AMENDMENT TO OPERATING LICENSE

Amendment No. 2
License No. DPR-16

ATTACHMENT A TO AMENDMENT NO. 2
JERSEY CENTRAL POWER & LIGHT COMPANY
LICENSE NO. DPR-16
CHANGE NO. 5 TO APPENDIX A

OYSTER CREEK NUCLEAR PLANT

FIGURE 2.1.1

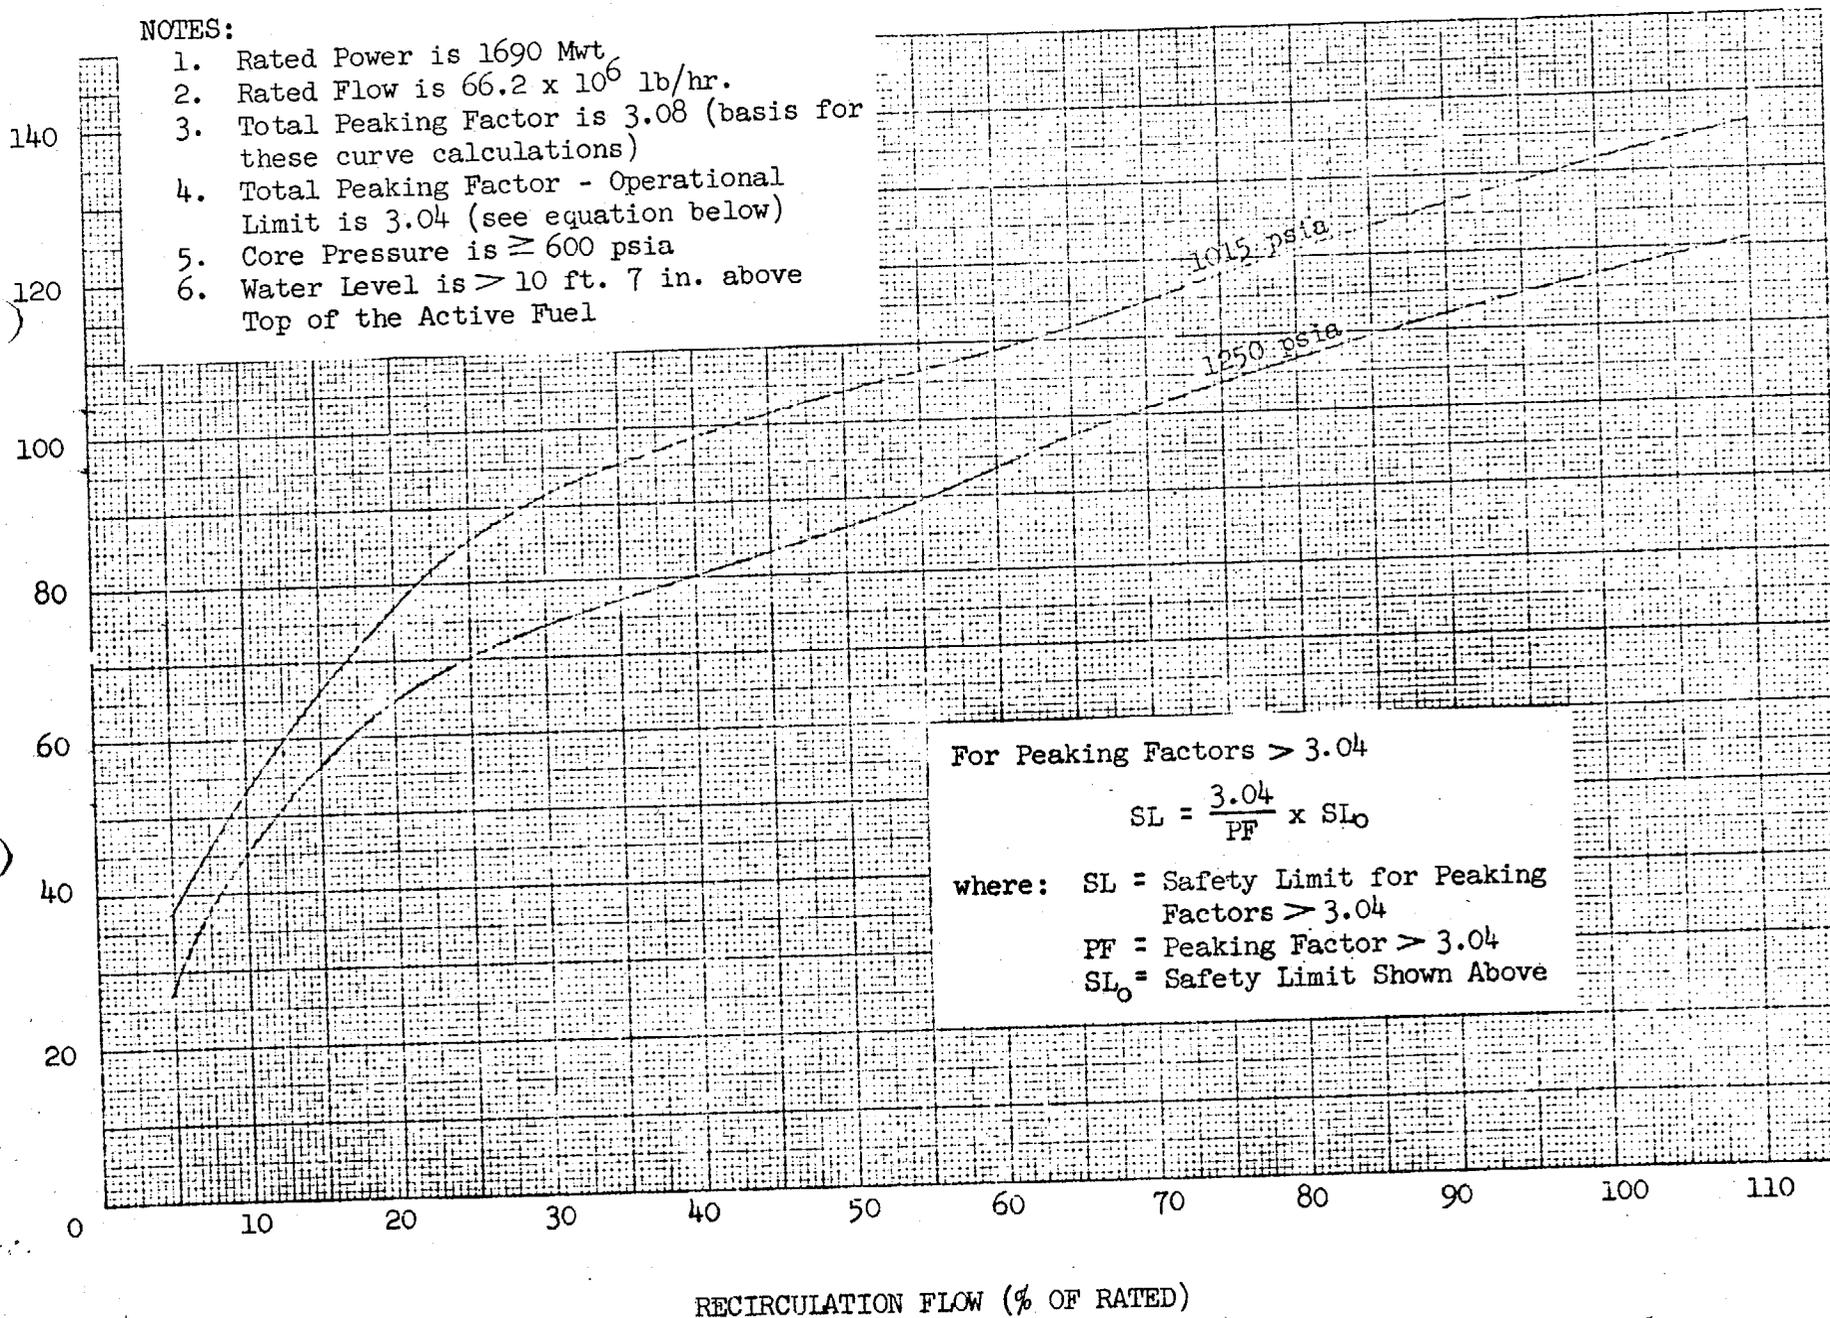
Replace Figure TS-1 with the attached
revised Figure 2.1.1.

FUEL CLADDING INTEGRITY SAFETY LIMIT
(Revised DEC 2 - 1970)

1. Rated Power is 1690 Mwt
2. Rated Flow is 66.2×10^6 lb/hr.
3. Total Peaking Factor is 3.08 (basis for these curve calculations)
4. Total Peaking Factor - Operational Limit is 3.04 (see equation below)
5. Core Pressure is ≥ 600 psia
6. Water Level is > 10 ft. 7 in. above Top of the Active Fuel

FIGURE 3.2.1 (Revised DEC 2 - 1970): SODIUM PENTABORATE SOLUTION VOLUME - CONCENTRATION REQUIREMENTS

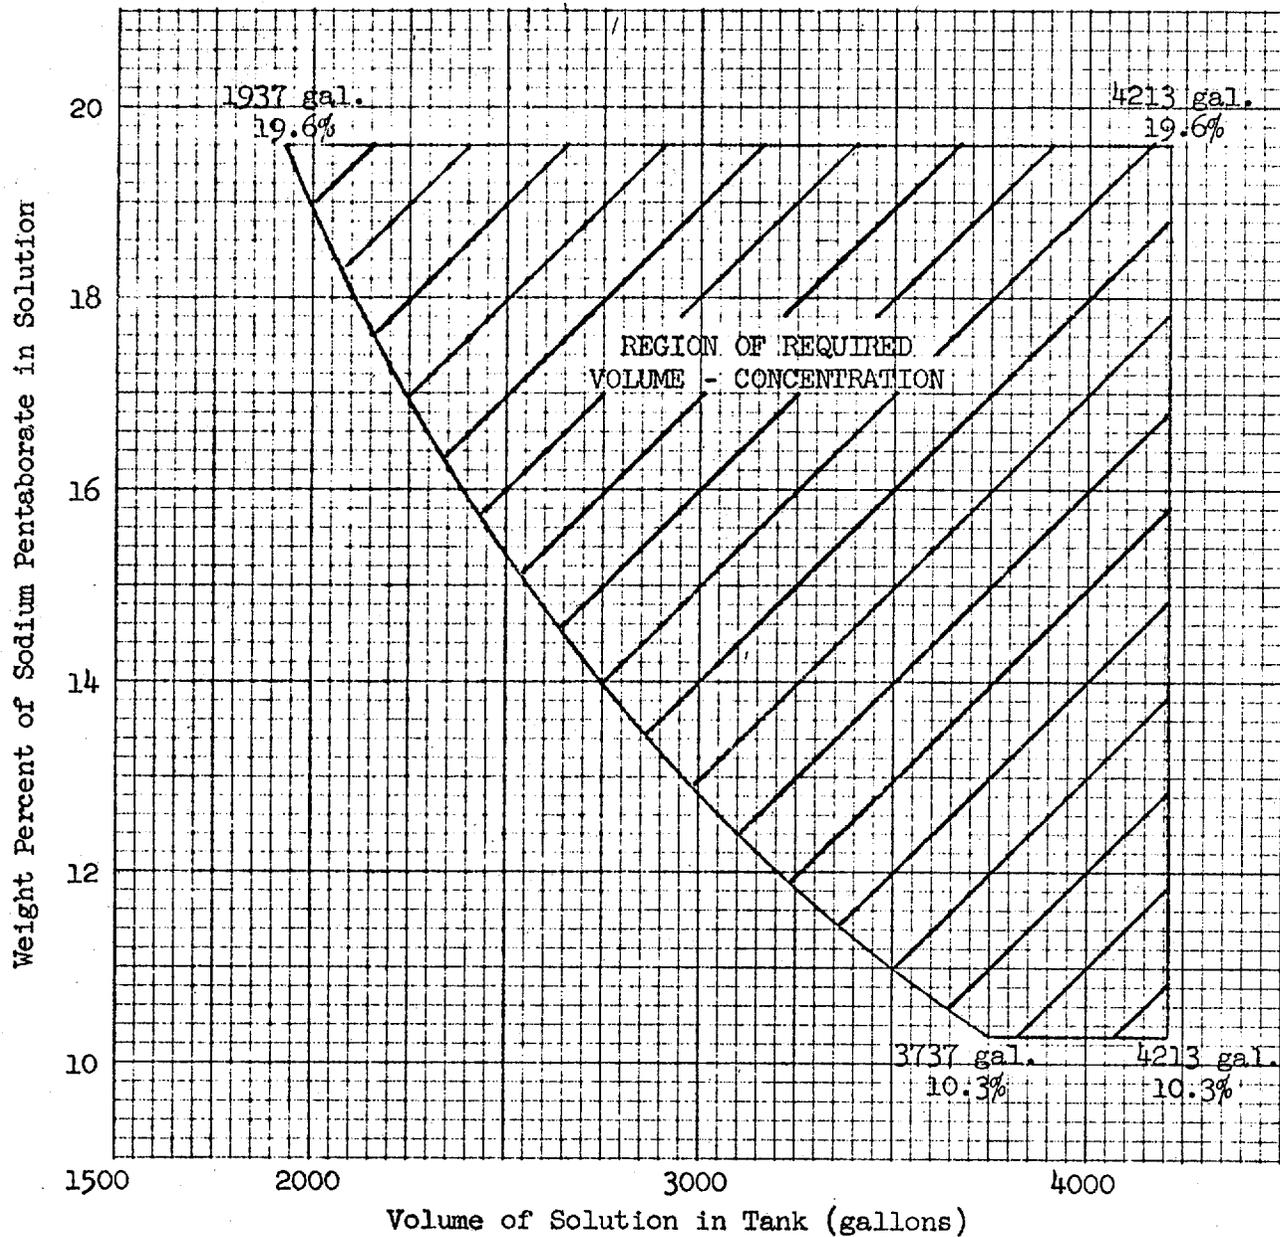
Replace Figure 3.2.1 with the attached revised Figure 3.2.1.
